#### II. RESPONSE TO OFFICE ACTION

Appl. No.: 10/089,0489 Reply to Office Action of September 23, 2004 Annotated Sheet Showing Changes

Fig. 8

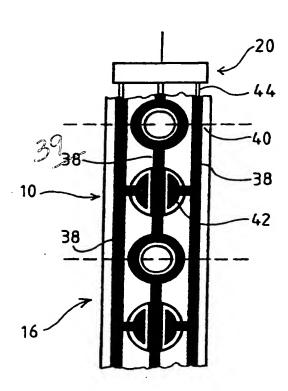
Filed concurrently herewith are corrected figures 8, 9 and 14. Specifically, in Figures 8 and 9, the central electrode track has been labeled the reference character "39" in response to the Examiner's objection to these figures. The specification has been amended accordingly.
